5133 University Avenue
Addendum No. 1, Contract 9021
MUNIS 13464
Developer: Degen & Associates, LLC

To: Timothy Troester, P.E. (City of Madison)
From: Carley Jones, P.E. (JSD Professional Services, Inc.)
Re: 5133 University Avenue (Contract 9021) – Box Culvert Conflict
JSD Project #: 07-2912
Date: January 5, 2022
cc: Tom Degen, Justin Frahm (JSD), Mark Brusberg, P.E. (Steven's), Susan Lasecki, P.E. (Ionic)

5133 University Avenue – Private Sanitary / Box Culvert Conflict Meeting
12/20/21 @ 10:00 AM via Zoom

ATTACHMENT 6 – PLAN MARKUP – OPTIONS FROM MEETING (12-20-
2021)

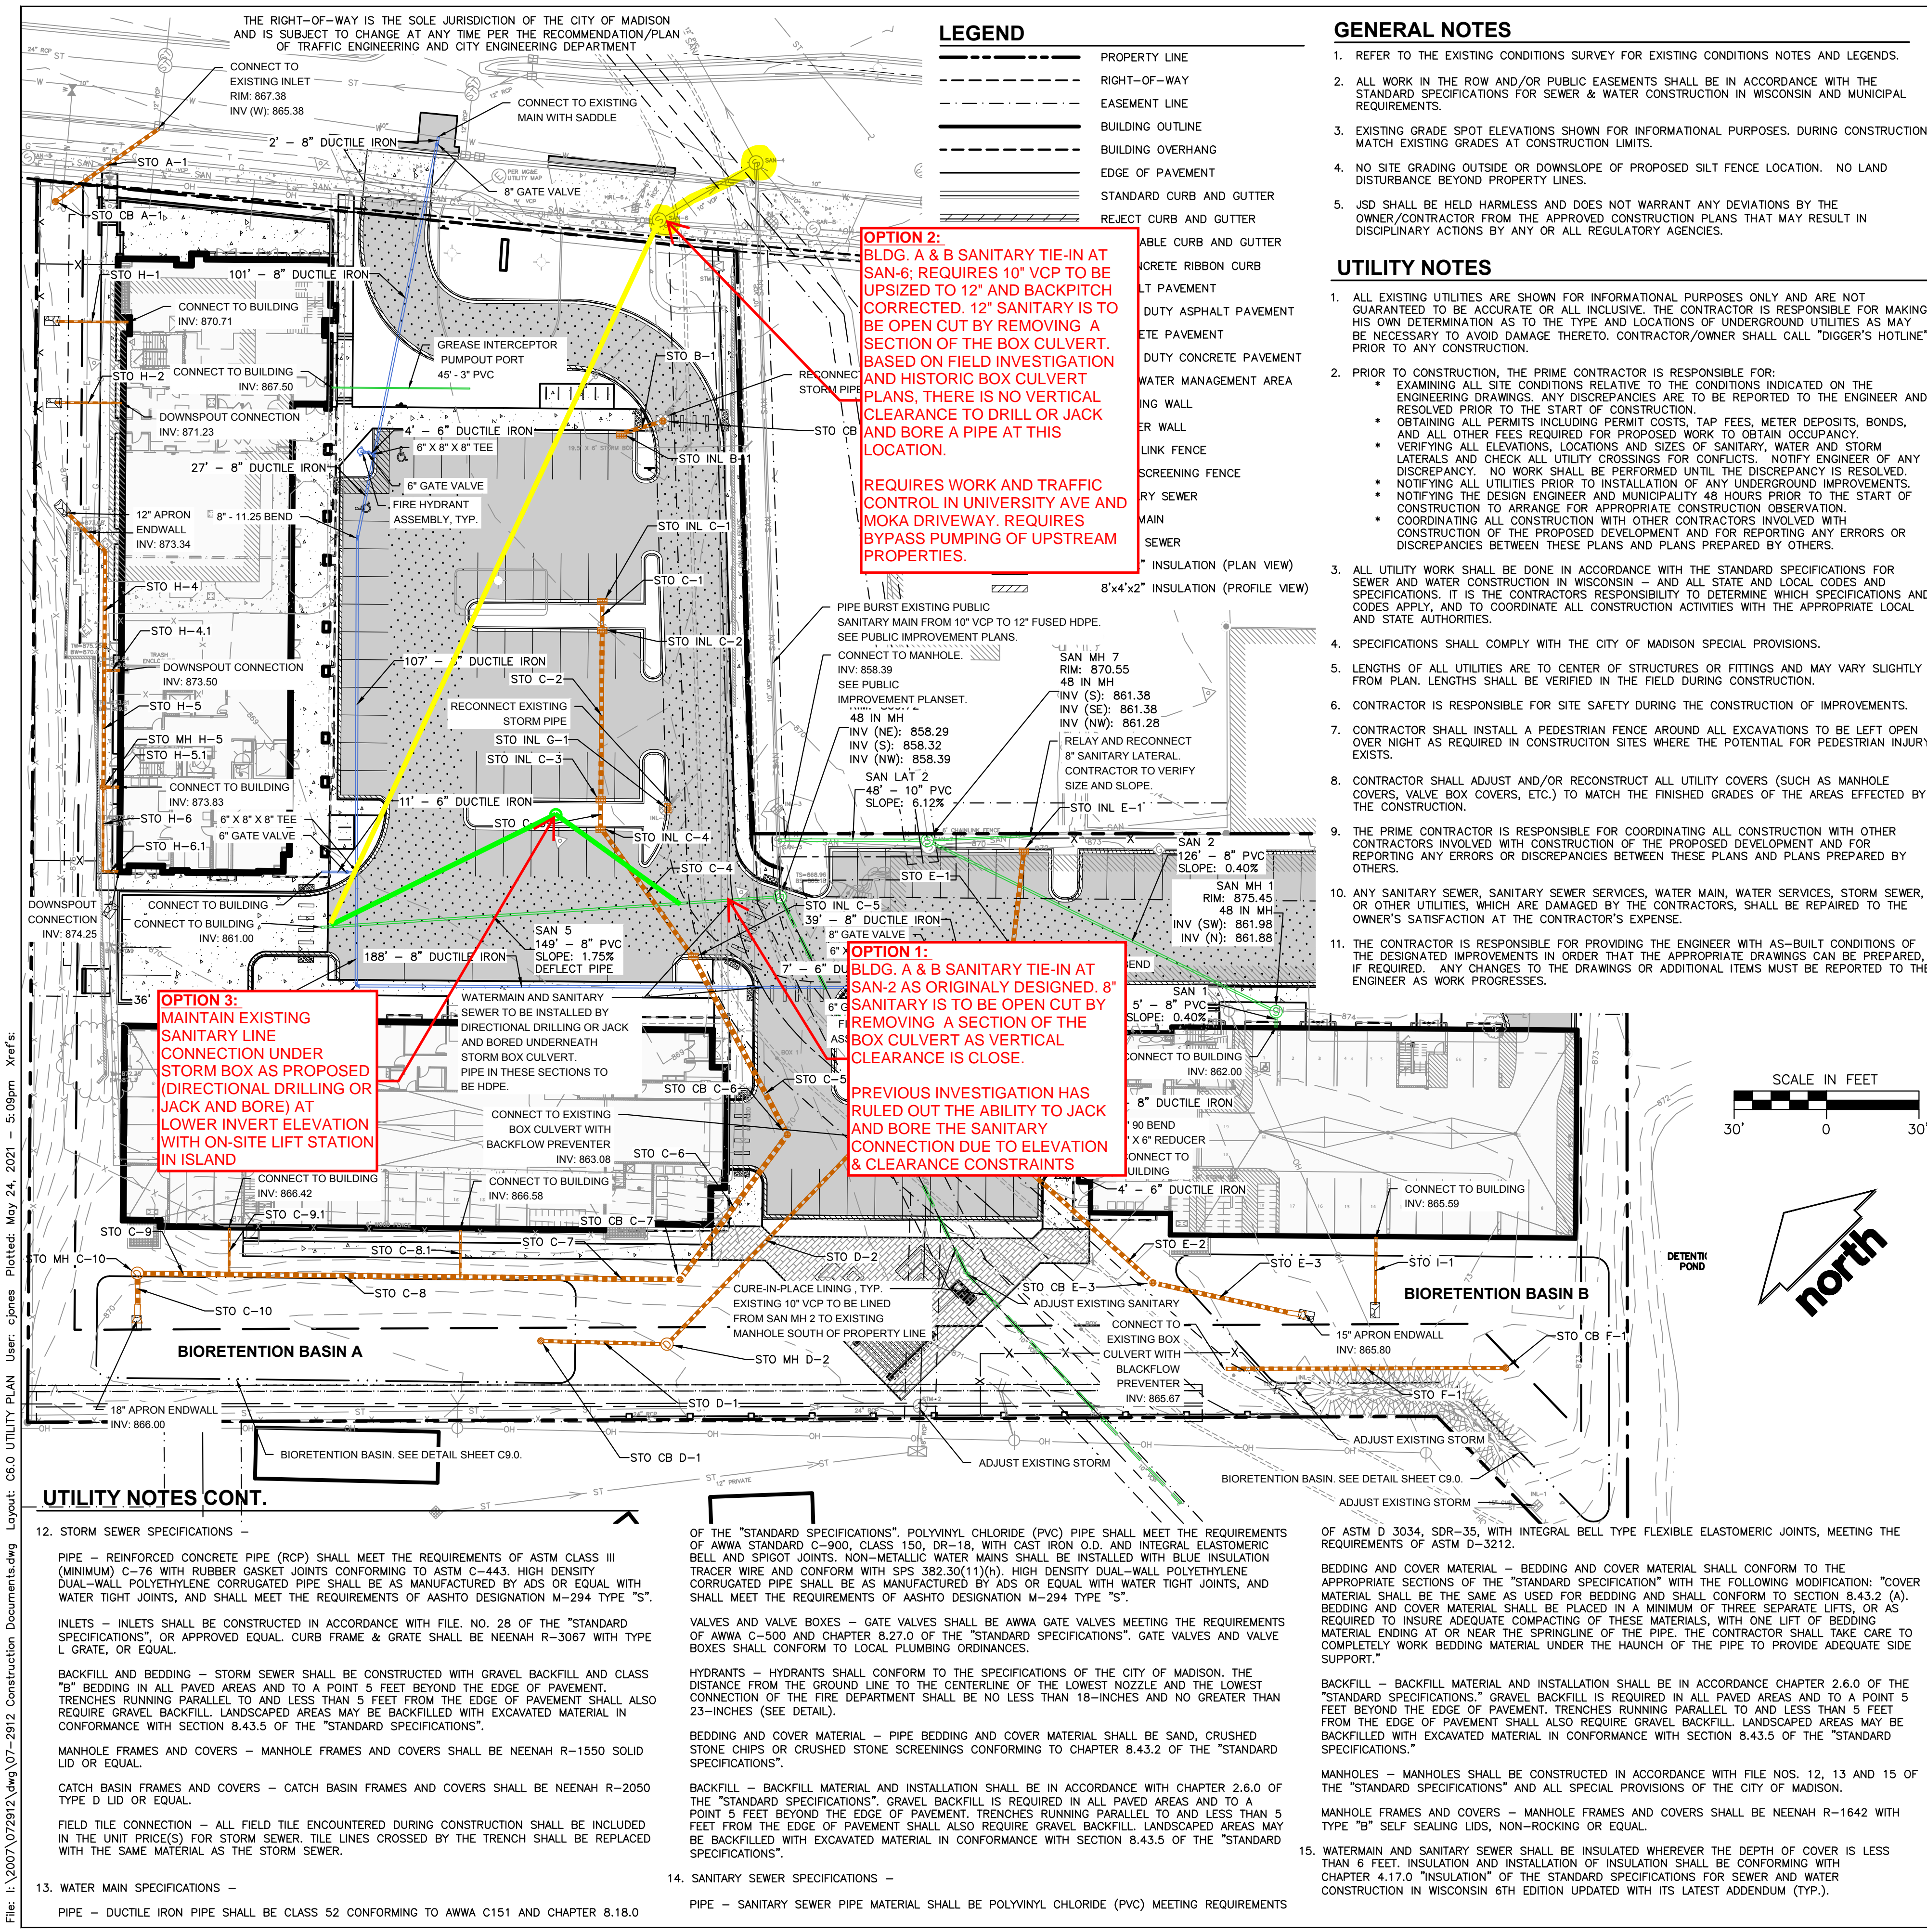
OPTION 3:
 MAINTAIN EXISTING SANITARY LINE CONNECTION UNDER STORM BOX AS PROPOSED (DIRECTIONAL DRILLING OR JACK AND BORE) AT LOWER INVERT ELEVATION WITH ON-SITE LIFT STATION IN ISLAND

OPTION 1:
 BLDG. A & B SANITARY TIE-IN AT SAN-2 AS ORIGINALLY DESIGNED. 8" SANITARY IS TO BE OPEN CUT BY REMOVING A SECTION OF THE BOX CULVERT AS VERTICAL CLEARANCE IS CLOSE.

PREVIOUS INVESTIGATION HAS RULED OUT THE ABILITY TO JACK AND BORE THE SANITARY CONNECTION DUE TO ELEVATION & CLEARANCE CONSTRAINTS

OPTION 2:
 BLDG. A & B SANITARY TIE-IN AT SAN-6; REQUIRES 10" VCP TO BE UPSIZED TO 12" AND BACKPITCH CORRECTED. 12" SANITARY IS TO BE OPEN CUT BY REMOVING A SECTION OF THE BOX CULVERT. BASED ON FIELD INVESTIGATION AND HISTORIC BOX CULVERT PLANS, THERE IS NO VERTICAL CLEARANCE TO DRILL OR JACK AND BORE A PIPE AT THIS LOCATION.

REQUIRES WORK AND TRAFFIC CONTROL IN UNIVERSITY AVE AND MOKA DRIVEWAY. REQUIRES BYPASS PUMPING OF UPSTREAM PROPERTIES.

As stated in the email from 12/20/2021 from Tim Troester (Attachment 8), this memo is to serve as the “memo or letter from the Developer or Developer’s Engineer on what their preferred option is.” The construction team and owner prefer and have decided to move forward with OPTION 1; which includes removal of a section of the box culvert, installation of the sanitary lateral at a slope of 0.4% along original proposed alignment, and the replacement of a section of the box culvert. This option will install the proposed sanitary lateral as originally indicated on the city-approved plans. See attachments for detail of the removal and replacement of the box culvert.
